SUBJECT: Duke Energy Carolinas, LLC (Duke Energy)  
Catawba Nuclear Station, Units 1 and 2  
Docket Nos. 50-413 and 50-414  
Final Responses to NRC Request for Additional Information (RAI) related to  
Generic Letter (GL) 2004-02, "Potential Impact of Debris Blockage on  
Emergency Recirculation During Design Basis Accidents at Pressurized-Water  
Reactors"

The purpose of this letter is to provide the formal Generic Letter 2004-02 Supplemental Response RAI responses for Catawba Nuclear Station.

**Catawba Nuclear Station**  
**Generic Letter 2004-02 Supplemental Response**  
**11/21/08 NRC RAI**  
**Final Response**

**Figure 12S-1: Top Hat Strainer Module Submergence Vortex Test Condition**

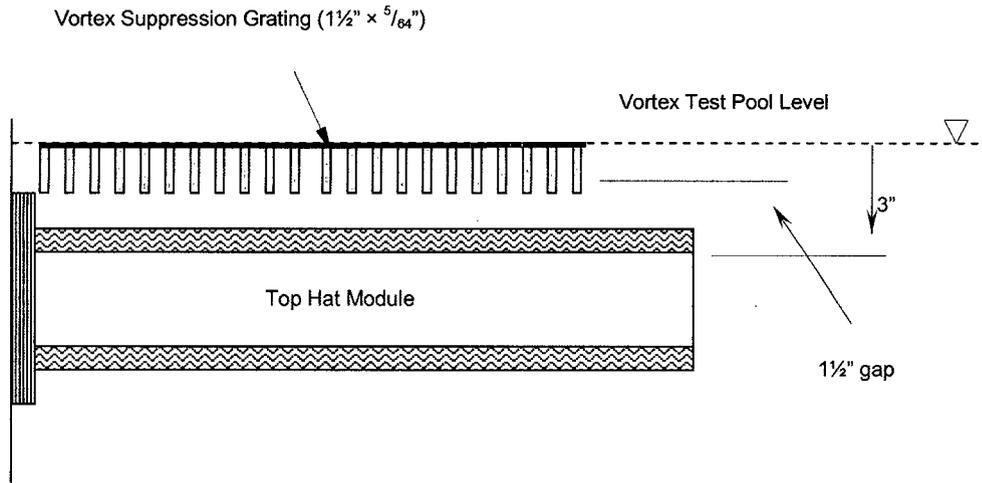
12. Please provide information that establishes that vortex testing was conducted at less than or equal to the expected 3.75-inch minimum strainer submergence. The licensee's response to RAI question 38 in Enclosure 1 to the supplemental response sent by letter dated February 28, 2008, and Enclosure 2 of this supplemental response, Section 3(f)(2), state that the strainer modules are submerged by 3.75 inches under limiting sump level conditions. The licensee's response to RAI question 38 states that testing was conducted at a submergence of 3 inches.

Enclosure 2, Section 3(f)(3), states that the testing was conducted with a "few inches" of water coverage above the strainer modules. Separately, Enclosure 2, Section 3(f)(3), states that approach velocities for testing were between 0.01 ft/sec and 0.09 ft/sec, while the expected maximum approach velocity for the plant strainer is 0.045 ft/sec. In order to clarify the conditions under which vortex testing was conducted, please provide the following information:

- a. Please provide the basis for the maximum approach velocity value of 0.045 ft/sec.
- b. Please discuss how flume velocity was controlled during vortex testing.
- c. Please provide a quantitative value for the approach velocity during which any vortices were observed to form.
- d. Please provide a quantitative value for the vortex suppressor grating submergence.
- e. Please verify that all vortex testing was conducted at less than or equal to 3.75 inches of strainer submergence, with or without a vortex suppressor grating.
- f. Please state whether vortex formation occurred during testing and what conditions were present at such times (submergence level, approach velocity and grating installation).

Refer to Figures 12S-1 and 12S-2 below for clarification of vortex grating submersion during testing and the as-built plant configuration.

*Note: The clearance dimensions provided in the CNS GL 04-02 Supplemental Response dated 2/29/08 were based on the as designed configuration and were based on the minimum clearance allowed between the top of the flow plenum and the bottom of the vortex suppression grating. The dimensions provided below refer to the as-built configuration.*

- f. Vortex testing was performed with a submergence level consistent with Figure 12S-1. Vortices were observed at flows of 0.04 feet per second and above without the vortex suppressor installed. With the vortex suppressor installed, no vortices were observed up to flows of 0.09 feet per second (approximately 2 times the maximum approach velocity of 0.051 ft/sec).
